Capital Facilities Planning

Addendum 3 – Questions and Answers

To: All Bidders
From: Sayim Malik
Project Manager, Capital Facilities Planning
Re: Project SU-022723 - Phase 3 Bathroom Rehab Project
DATE: JUNE 26, 2023

Date	06-15-2023
Project No.	1944
Drawing By	LJ
CHK By	SM
Scale	AS NOTED
	DOB Rev
E-103.00

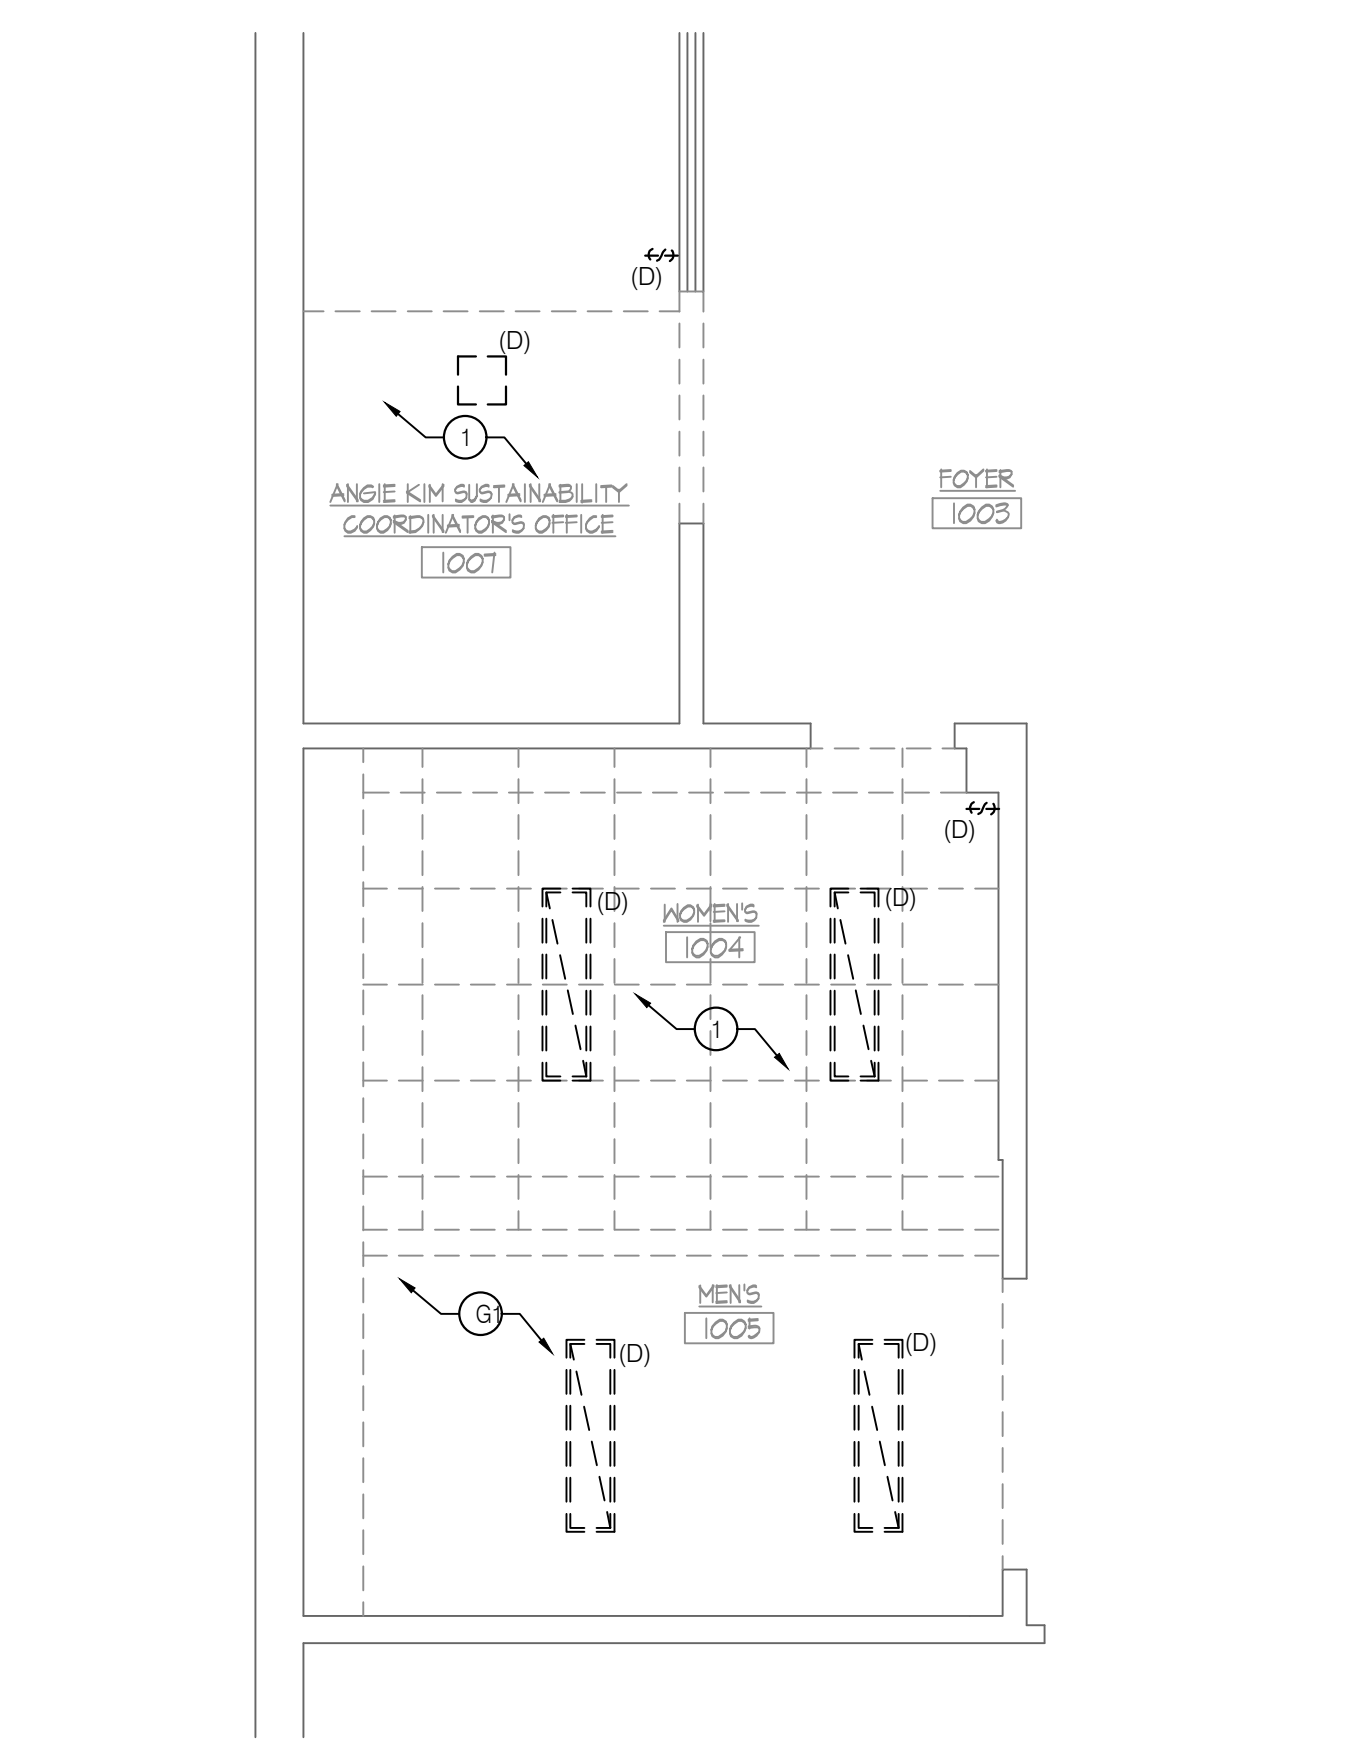
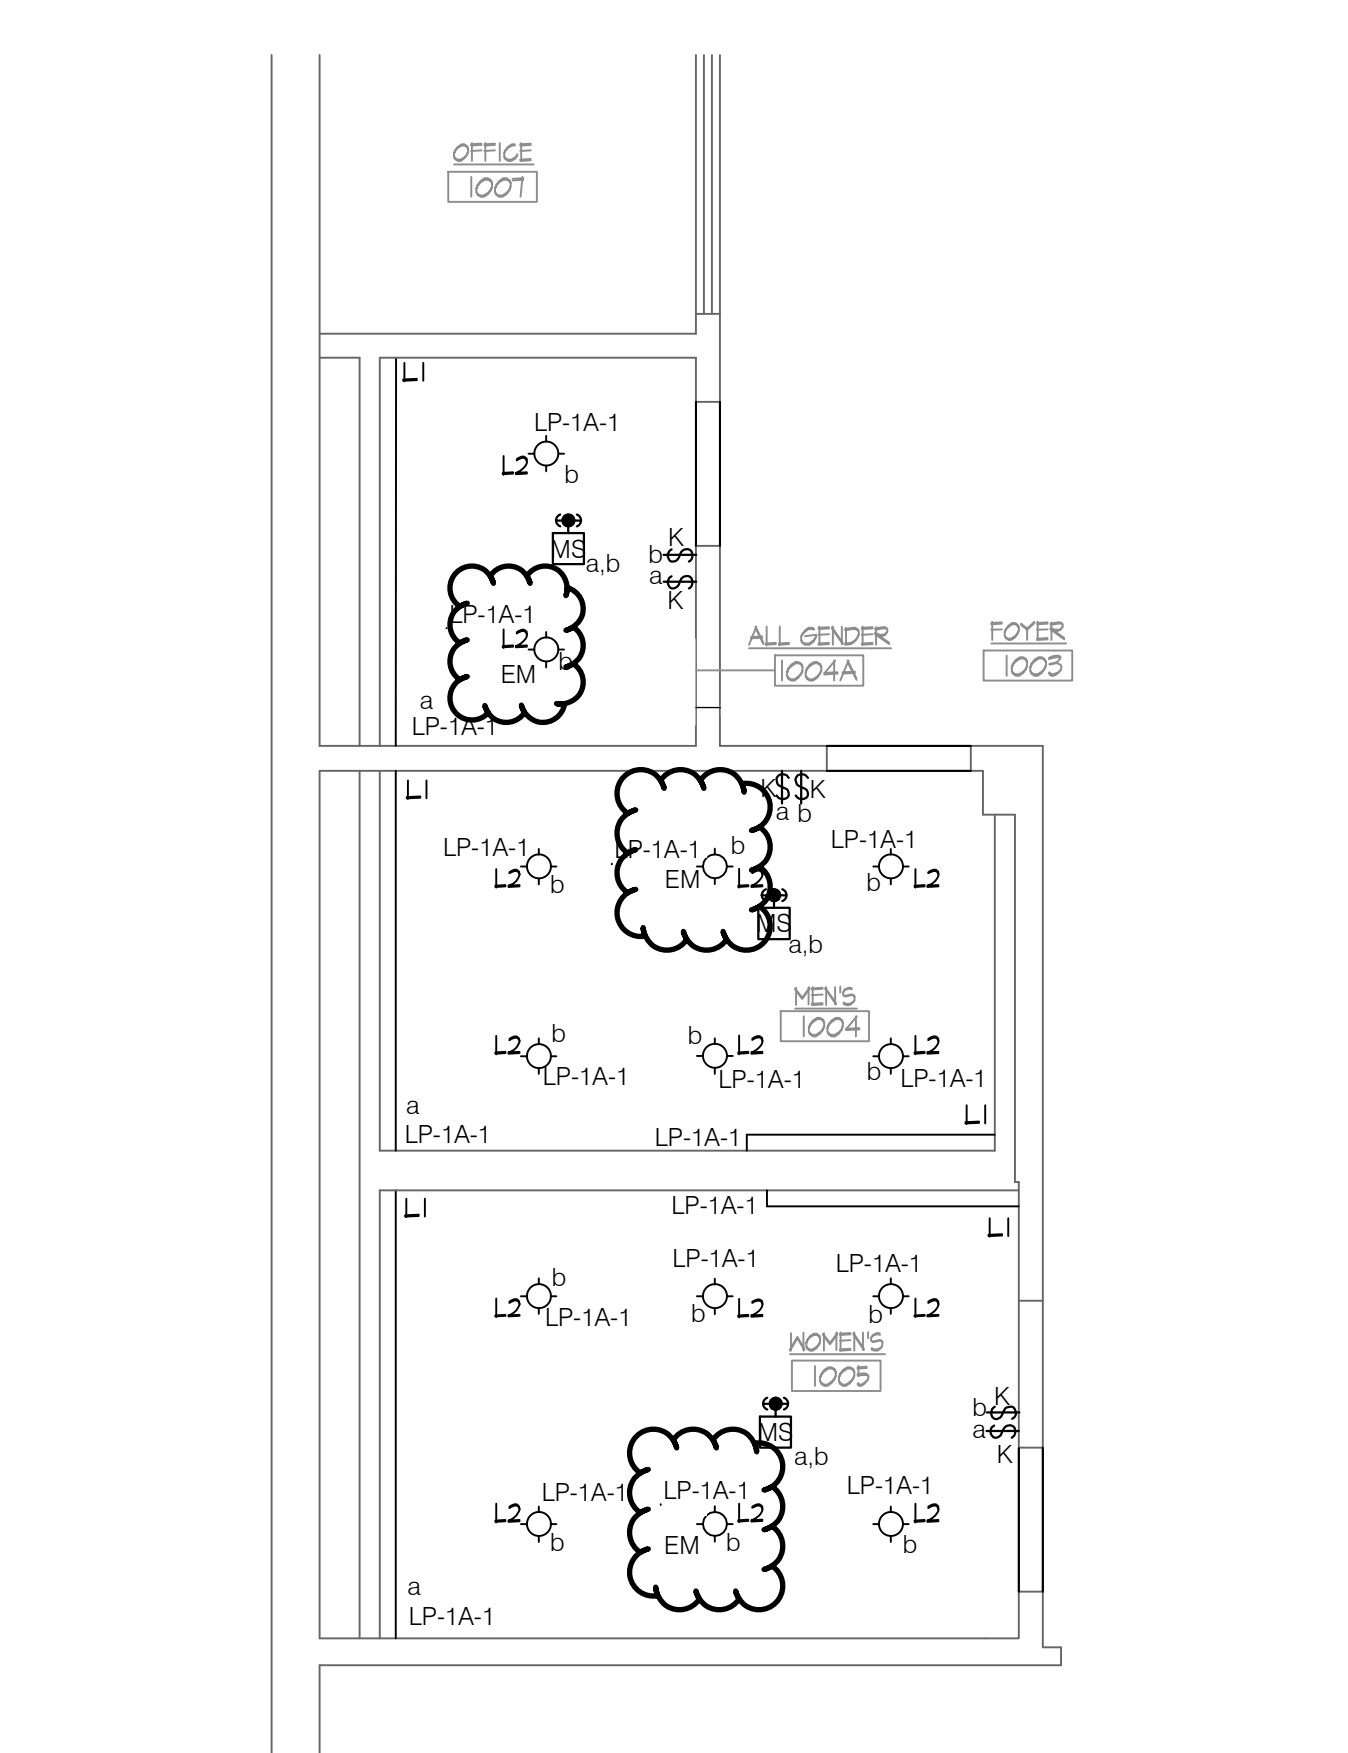
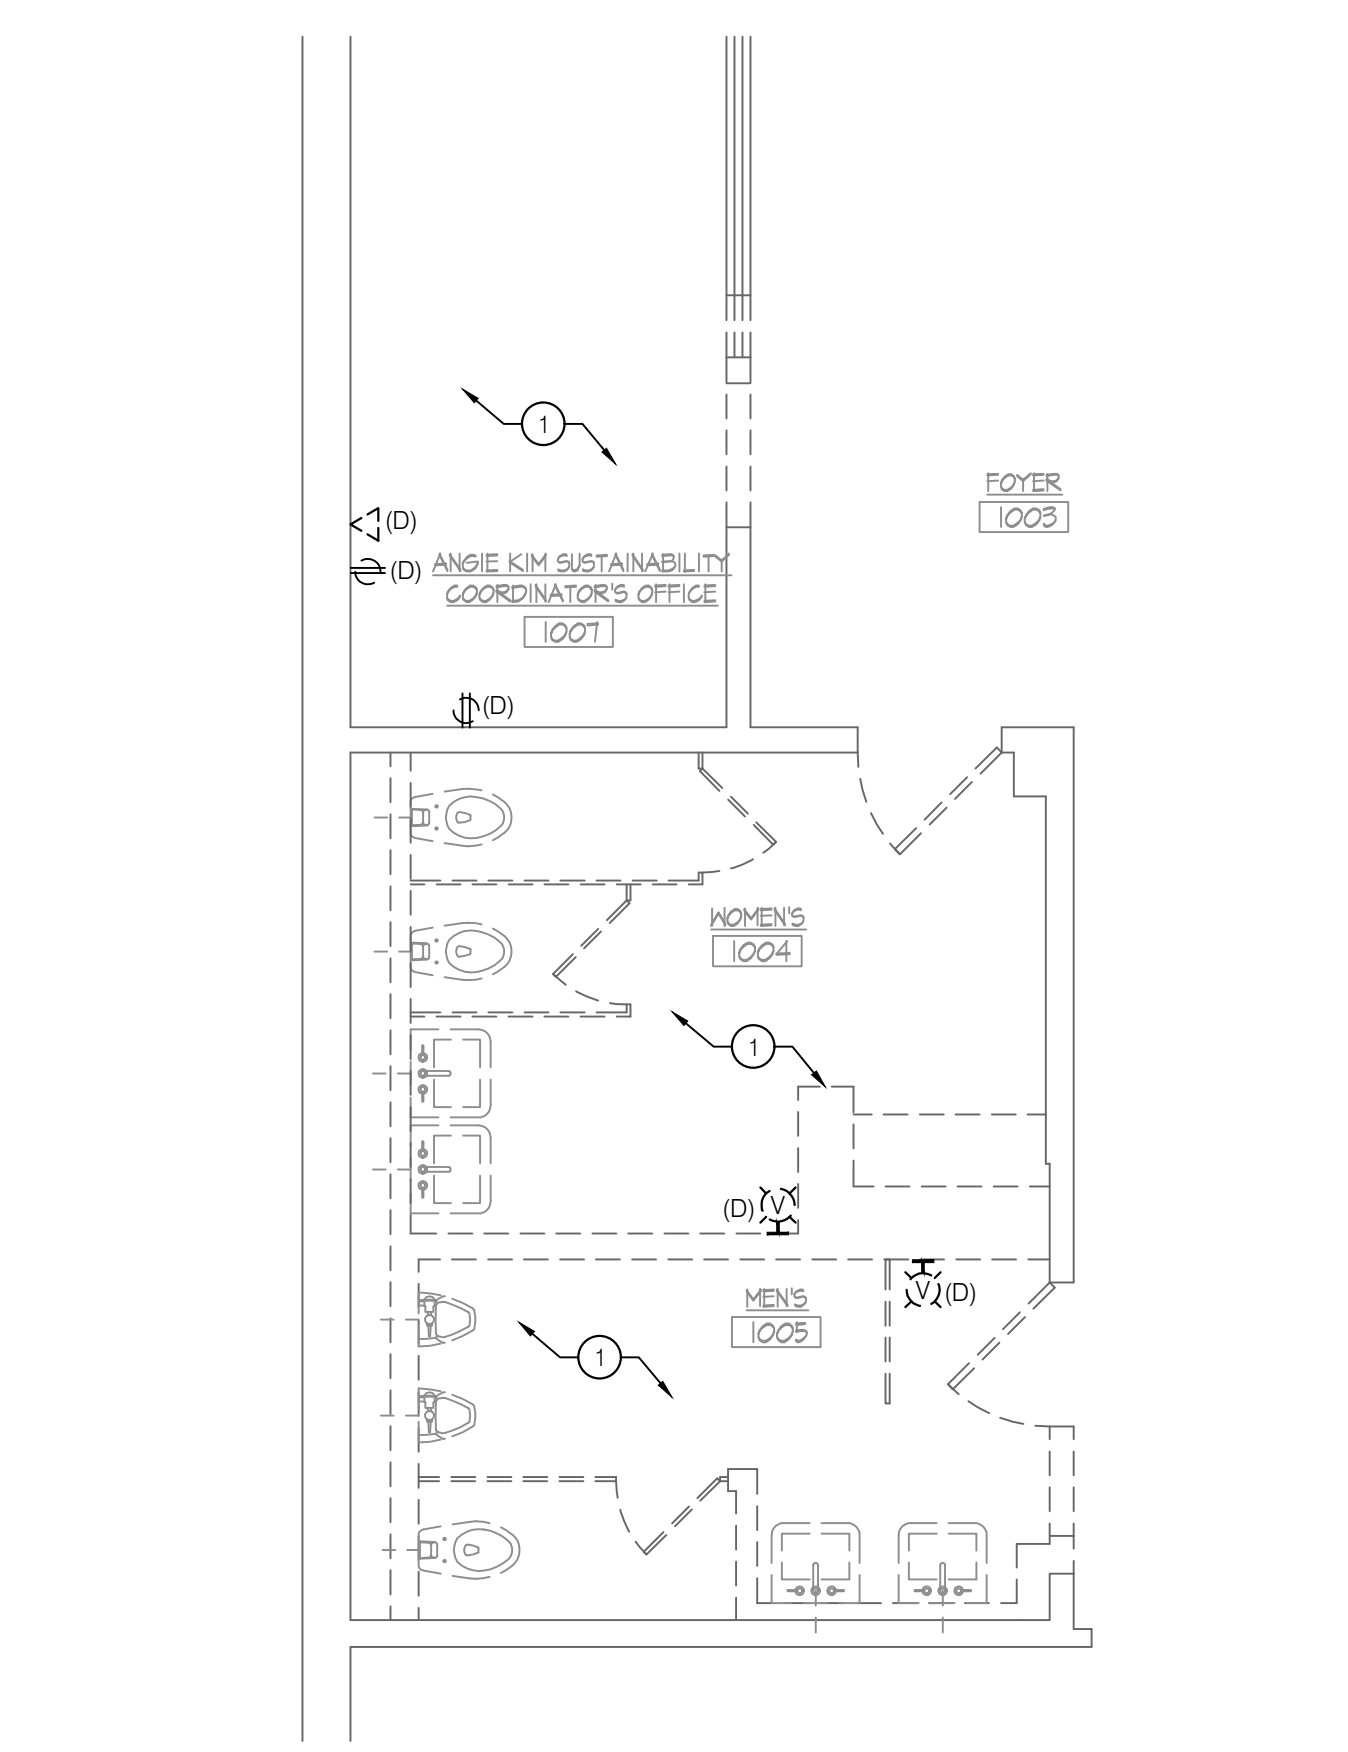
- Question 8: Campus Center South provide a Key Plan to Scale showing the Area of Work and the Electric Closet.
- Answer 8 *Key plan is indicated in the title-block on this sheet. Electrical room has been called out for reference. Refer to E-103.*

- Answer 11: *Please note that all EM fixtures are battery backups.*
- Question 12: Drawing E-103.00 Sheet Key Note #2-provide a Key Plan to Scale identifying the location of the nearest Emergency Panel.

- Answer 12: *Please note that all EM fixtures are battery backups.*
- Question 13: Drawing E-501.00 Detail #3 Partial Electric Risers-Panels are shown three phase yet the Panel Schedules on Drawings E-601.00, E-602.00 and E-603.00 depict Panels as single phase. Clarify three phase or single phase panels.
